Project: 2023 Emergency Culvert Repair Project

Item: Addendum #2

5TH STREET EMERGENCY CULVERT REPAIR

CURB & GUTTER DETAIL

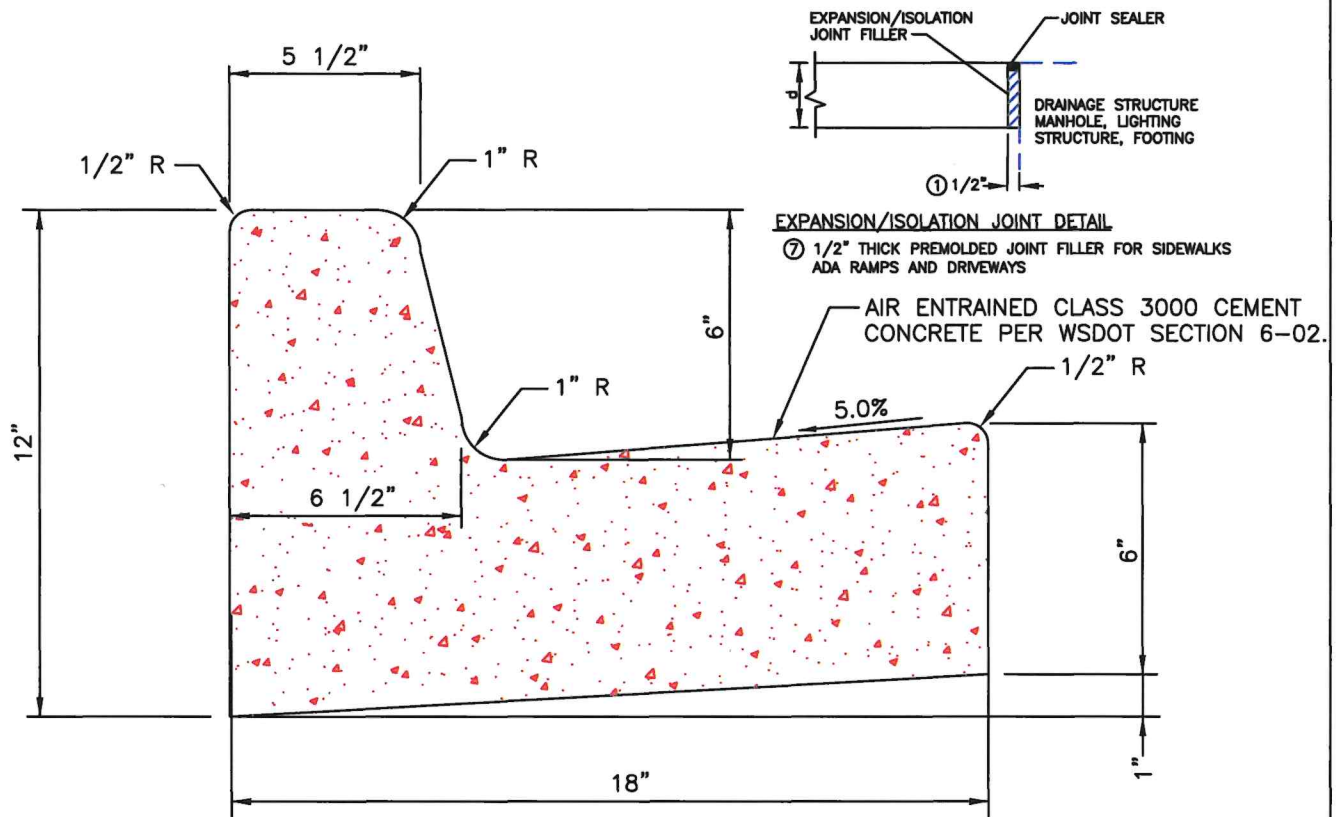
- Traffic Control has been eliminated from the bid items.
- Sidewalk and curb and gutter removed for the pipe repair will need to be removed and replaced per the city details.
- The backfill specifications have been modified to allow native backfill outside of the roadway prism along the pipe length if approved in the field by the City Engineer.
- The bypass pumping rate has been estimated to be approximately 10 CFS.
- A new bid schedule is attached adding bid items for curb and gutter and sidewalk repair and removing traffic control.

SCHEMATIC CULVERT REPLACEMENT PLAN

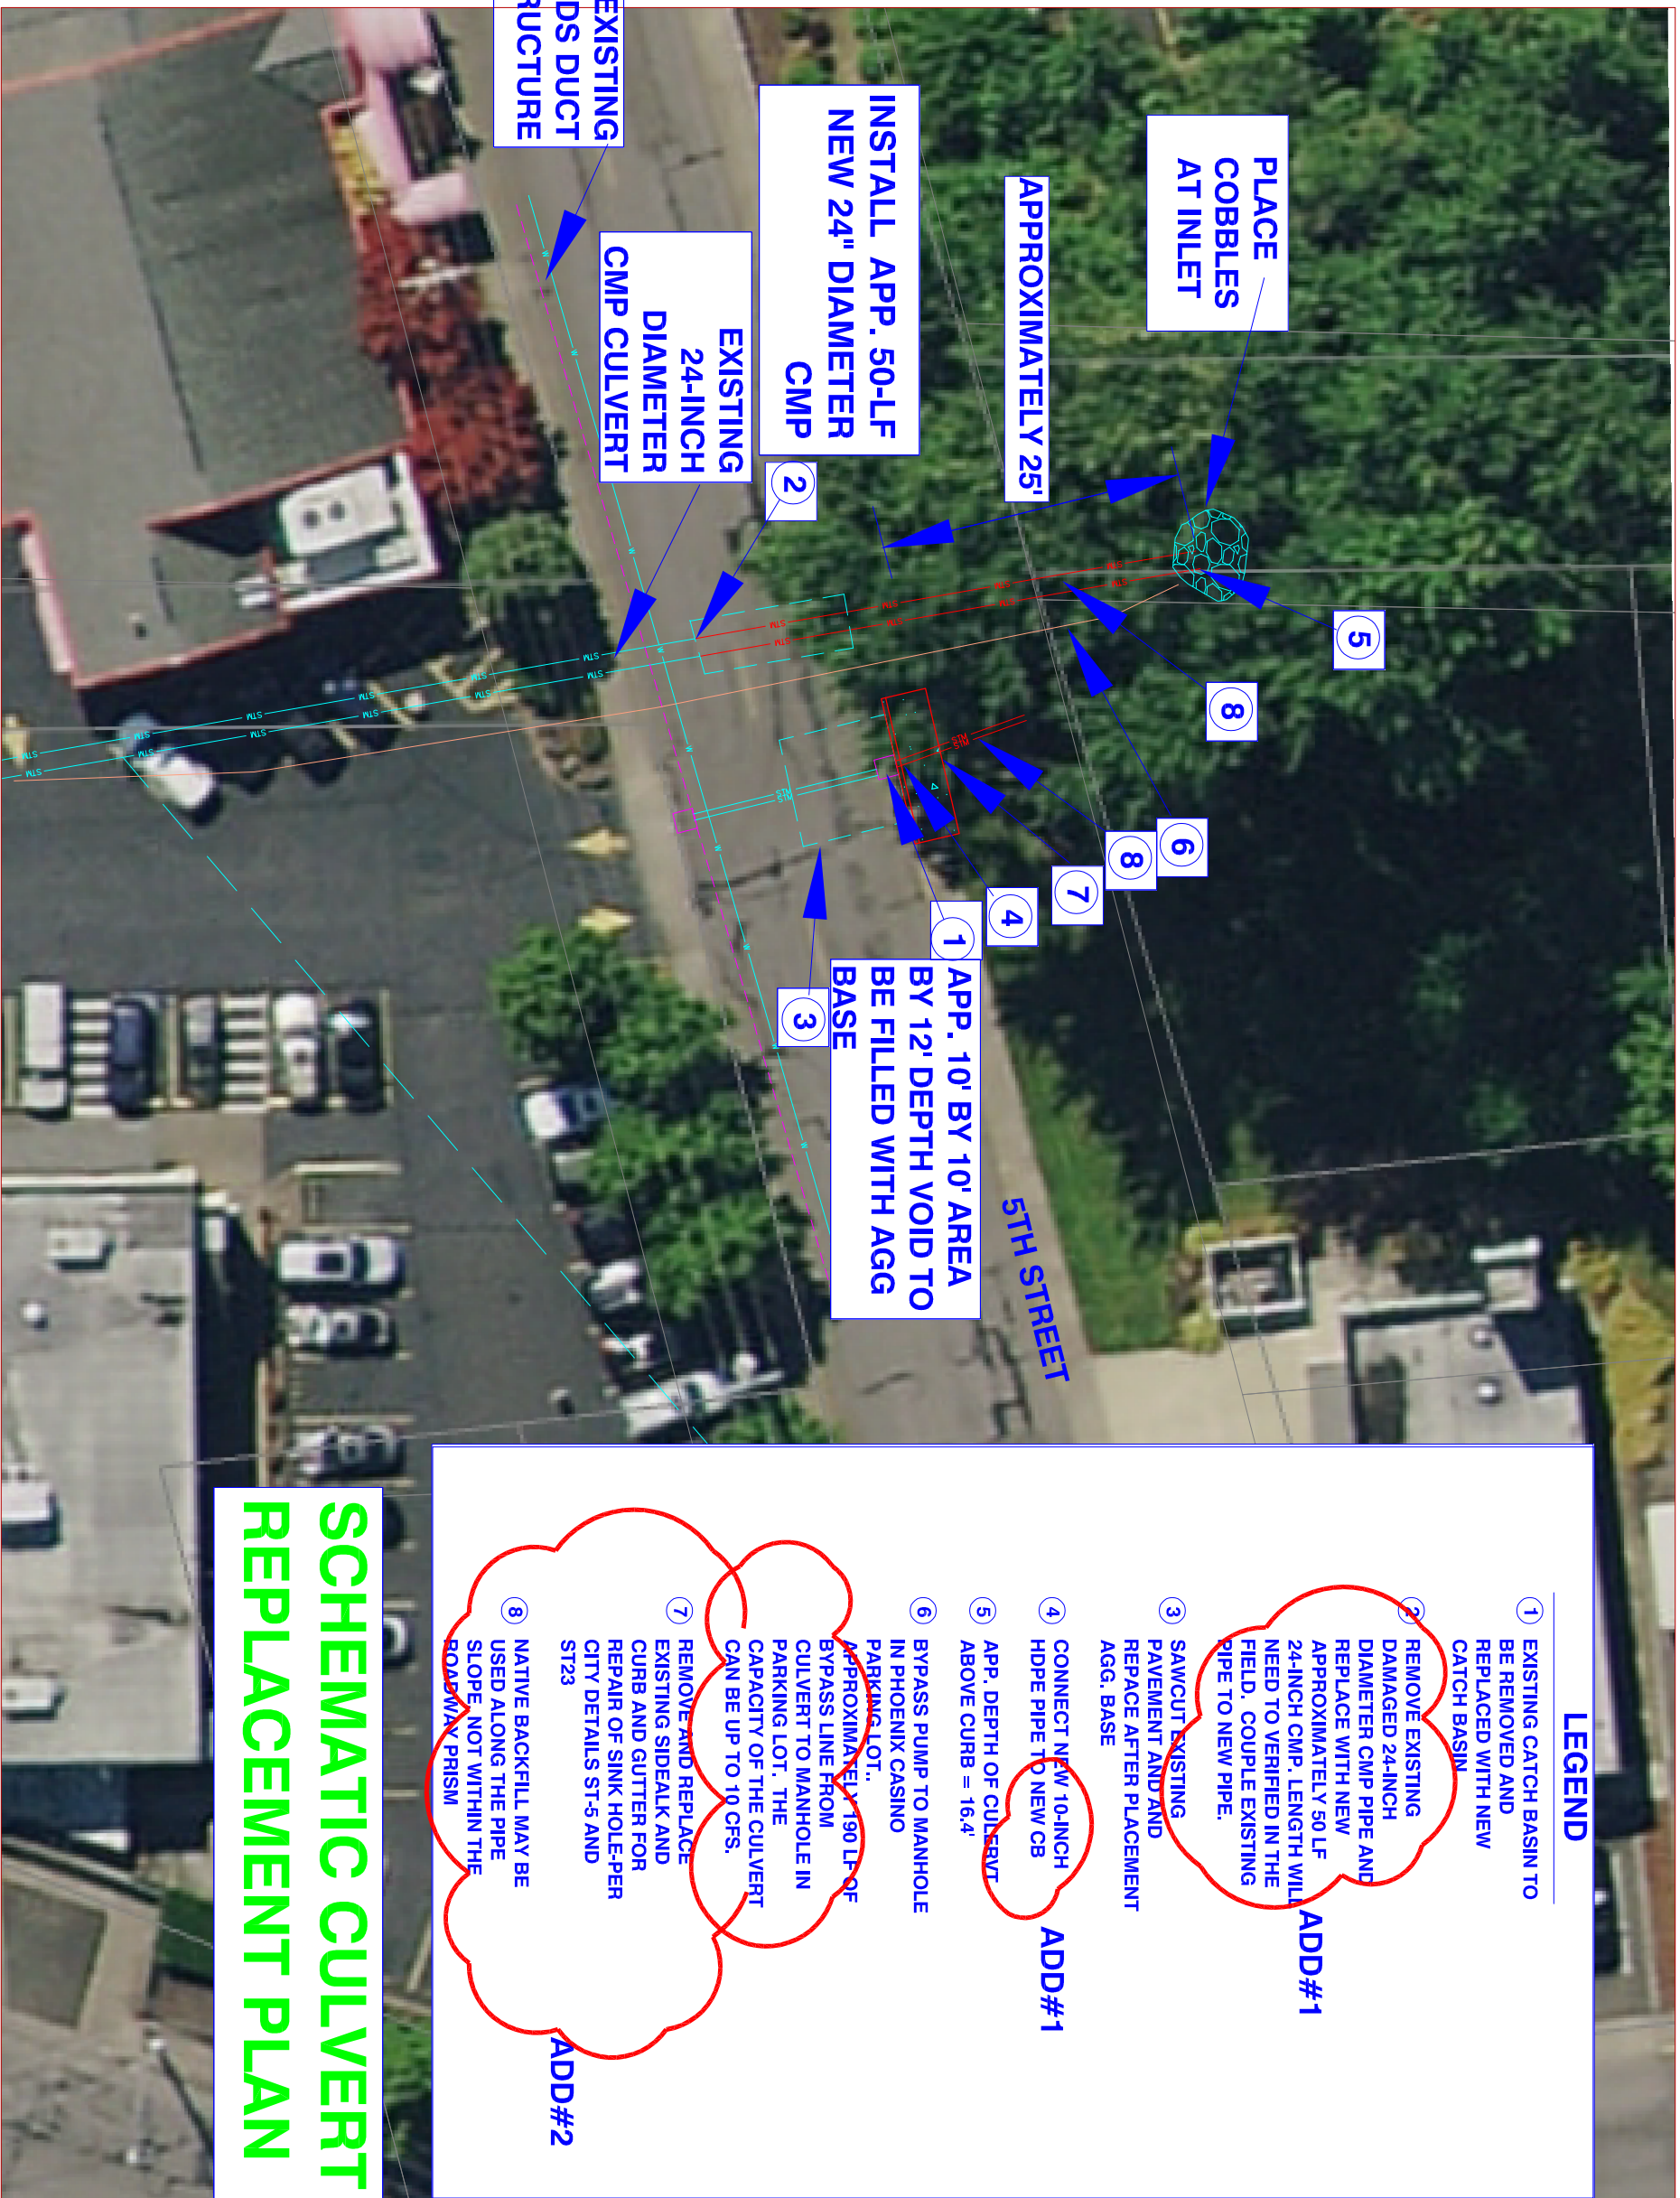
- ① EXISTING CATCH BASIN TO BE REMOVED AND REPLACED WITH NEW CATCH BASIN.
- ② REMOVE EXISTING DAMAGED 24-INCH DIAMETER CMP PIPE AND REPLACE WITH NEW APPROXIMATELY 50 LF 24-INCH CMP. LENGTH WILL NEED TO BE VERIFIED IN THE FIELD. COUPLE EXISTING PIPE TO NEW PIPE. ADD#1
- ③ SAWCUT EXISTING PAVEMENT AND AND REPLACE AFTER PLACEMENT AGG. BASE
- ④ CONNECT NEW 10-INCH HDPE PIPE TO NEW CB ADD#1
- ⑤ APP. DEPTH OF CULVERT ABOVE CURB = 16.4'
- ⑥ BYPASS PUMP TO MANHOLE IN PHOENIX CASINO PARKING LOT. APPROXIMATELY 190 LF OF BYPASS LINE FROM CULVERT TO MANHOLE IN PARKING LOT. THE CAPACITY OF THE CULVERT CAN BE UP TO 10 CFS.
- ⑦ REMOVE AND REPLACE EXISTING SIDEWALK AND CURB AND GUTTER FOR REPAIR OF SINK HOLE-PER CITY DETAILS ST-5 AND ST-23 ADD#2
- ⑧ NATIVE BACKFILL MAY BE USED ALONG THE PIPE SLOPE. NOT WITHIN THE ROADWAY PRISM

The roadway prism shall be excavated, with bedding, backfill and fill being replaced with 1 1/4" aggregate base. For fill outside of the roadway prism, along the pipe slope, bedding, and haunching and shall be 1 1/4" aggregate base. Native backfill may be able to be used if the City Engineer determines that it is acceptable to use and compact.
